**CEDAR CREEK STREAM AND WETLAND RESTORATION
PROJECT
MONITORING REPORT
MONITORING YEAR 4
FINAL**

SAMPSON COUNTY, NORTH CAROLINA
CONTRACT No. 005011 - PROJECT No. 95718
USACE ACTION ID No. 2012-00389 – NCDWR PROJECT No. 2013-0186

RE: Cedar Creek Stream and Wetland Restoration Site: MY4 Monitoring Report (NCDMS ID 95718)

Listed below are comments provided by DMS on December 14, 2018 regarding the Cedar Creek Stream and Wetland Restoration Site: Year 4 Monitoring Report and RES' responses.

Figure 8. 2018 Cedar Creek Groundwater Monitoring Gauge Hydrographs

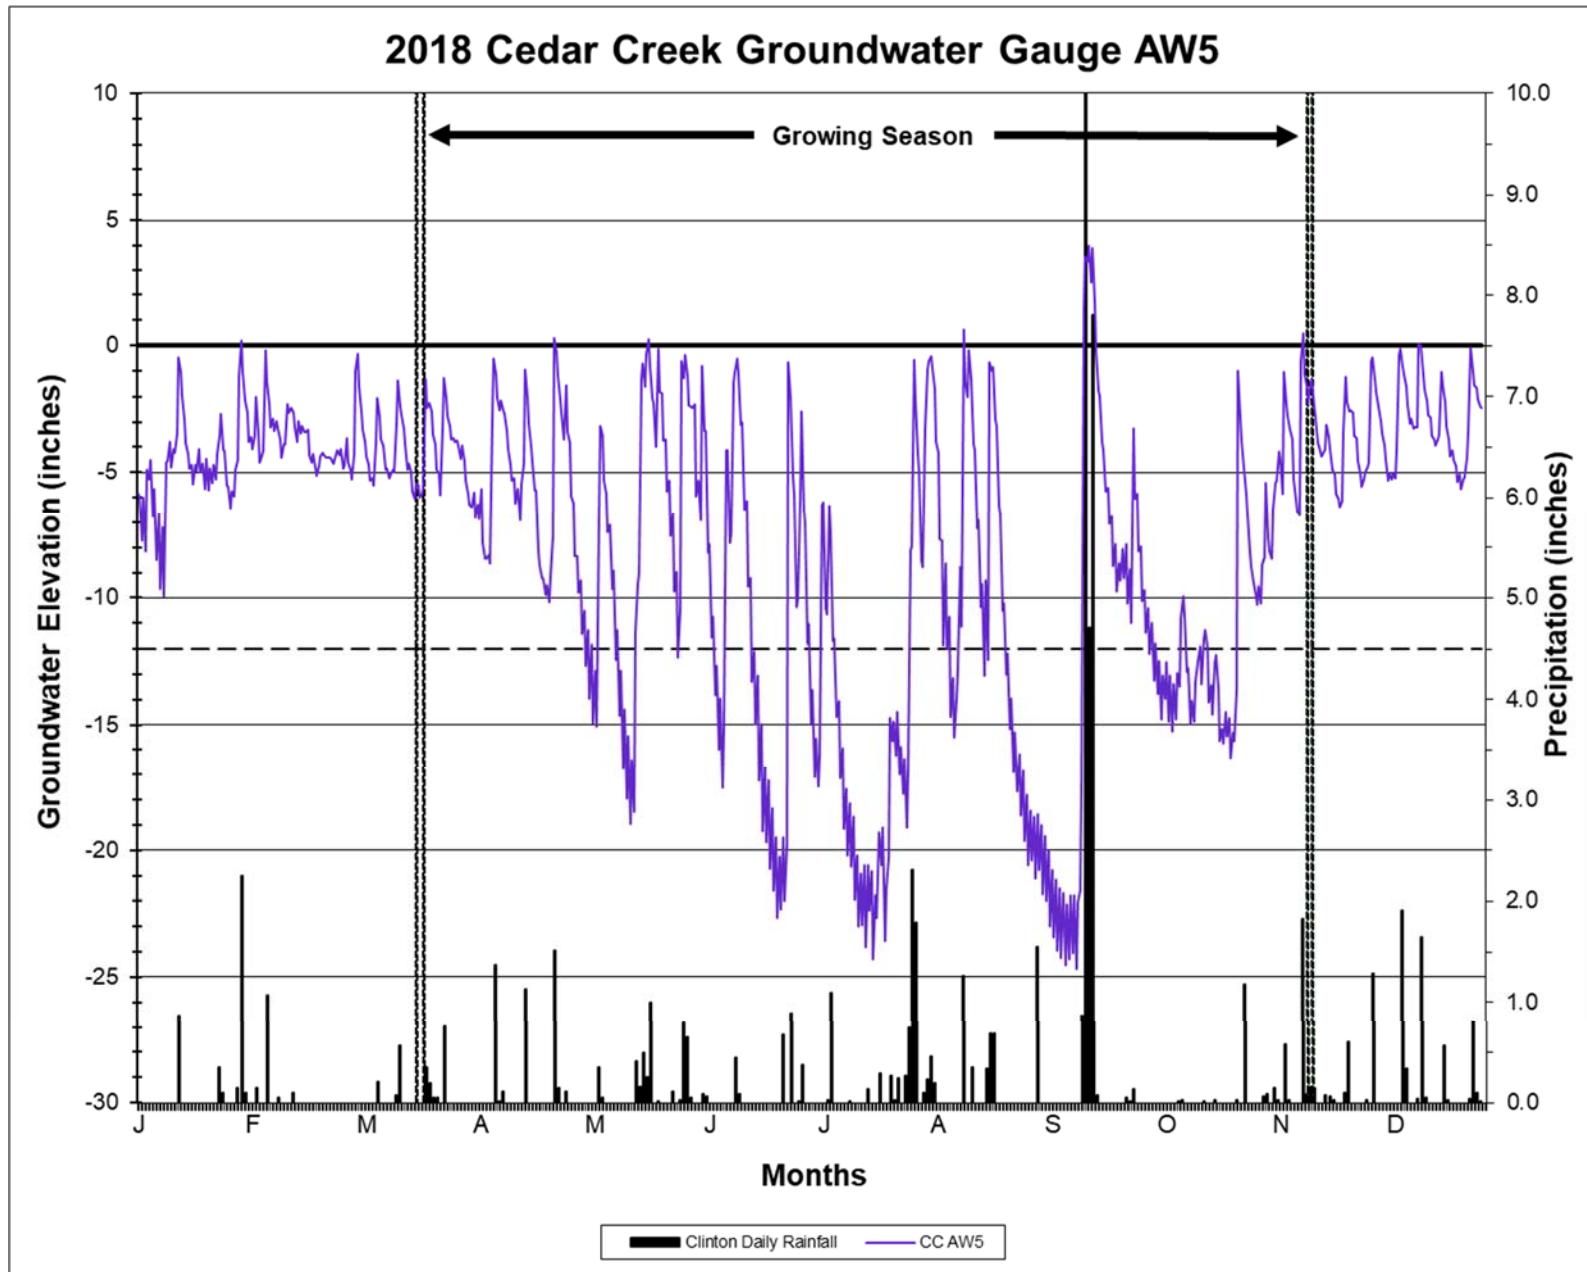
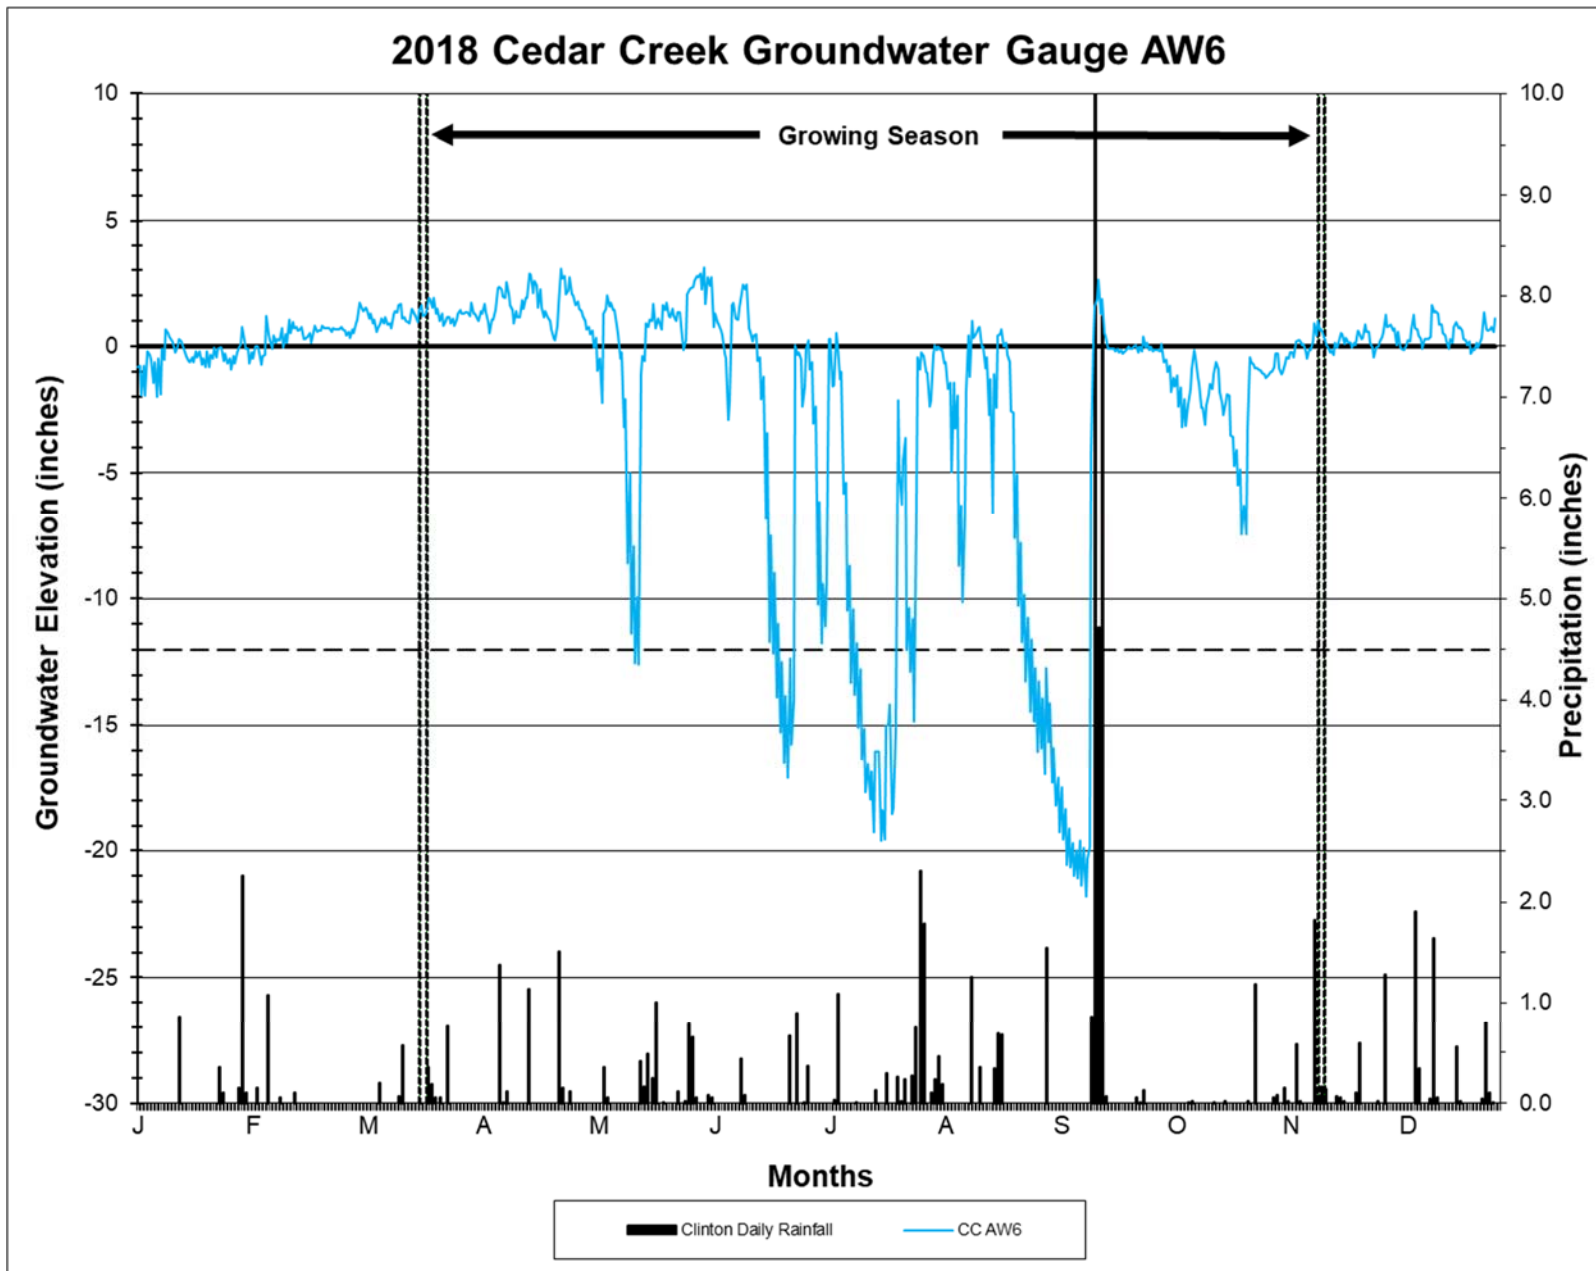
8. **Appendix E:**
 - a. 2018 Groundwater Monitoring Gauge Hydrographs: In reviewing these hydrographs, it appears that the entire growing season was not observed for the wetland assessment/gauge data collection. Please explain why not.
RES collected additional groundwater monitoring on January 10, 2019. The report now includes data from the entire growing season.
